ORDINANCE NO. 2025-03-15

AN ORDINANCE OF THE CITY OF LANCASTER, TEXAS REPEALING THE INTERNATIONAL RESIDENTIAL CODE (2015 EDITION) AND ADOPTING THE INTERNATIONAL RESIDENTIAL CODE (2021 EDITION) WITH LOCAL AMENDMENTS; PROVIDING A PENALTY OF FINE NOT TO EXCEED TWO THOUSAND DOLLARS (\$2,000). PROVIDING FOR SEVERABILITY; PROVIDING A SAVINGS CLAUSE; PROVIDING A REPEALING CLAUSE (WITH AN EXCEPTION FOR PENDING PROSECUTIONS); AND PROVIDING FOR AN EFFECTIVE DATE.

Figure 307.4

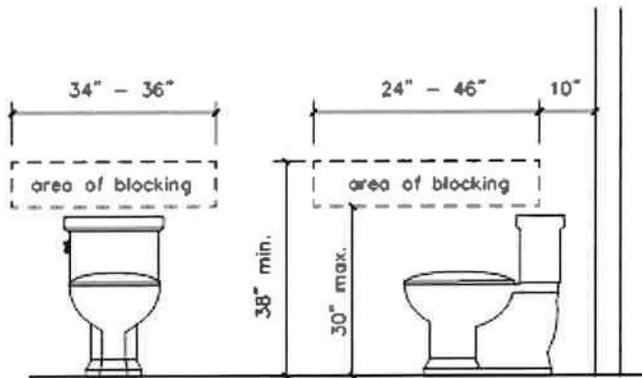
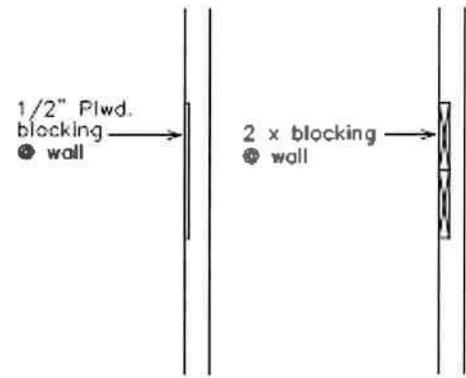
*****R307.3 Blocking.** Required at one toilet at grade level. Blocking per Sec. R307.4 and Figure 307.4, shall be installed at rear wall and one wall adjacent to toilet at the lowest living level where a toilet is provided.

*****R307.4 Blocking.** Blocking may be 1/2" plywood or equivalent or 2 x solid wood blocking flush with wall.

****Figure R602.6.1; delete the figure and insert the following figure:**

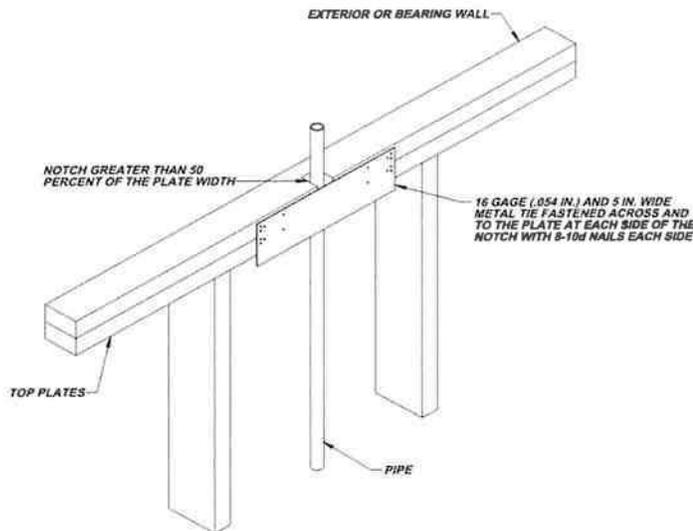
R602.6.1 Drilling and notching of top plate. When piping or ductwork is placed in or partly in an exterior wall or interior load-bearing wall, necessitating cutting, drilling or notching of the top plate by more than 50 percent of its width, a galvanized metal tie not less than 0.054 inch thick (1.37 mm) (16 Ga) and 4-½ inches (38 mm) ~~5 inches (127 mm)~~ wide shall be fastened across and to the plate at each side of the opening with not less than eight 10d (0.148 inch diameter) having a minimum length of 1 ½ inches (38 mm) at each side or equivalent. Fasteners will be offset to prevent splitting of the top plate material. The metal tie must extend a minimum of 6 inches past the opening. See figure R602.6.1. {remainder unchanged}
